TECHNICAL INFORMATION

- Subject** ▶ Change of Motor Housing
- For Models** ▶ HR2410,HR2413
- Description** ▶ As illustrated below, motor housing has been changed for improvement in insulation.

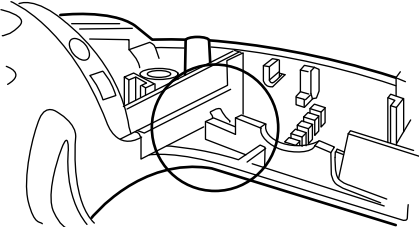
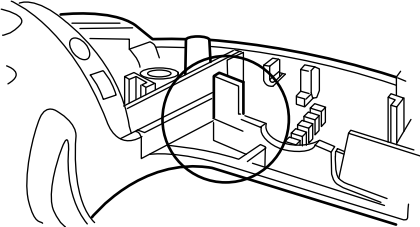
▶ Current	▶ New
	 <p>A rib has been added where switch is placed.</p>
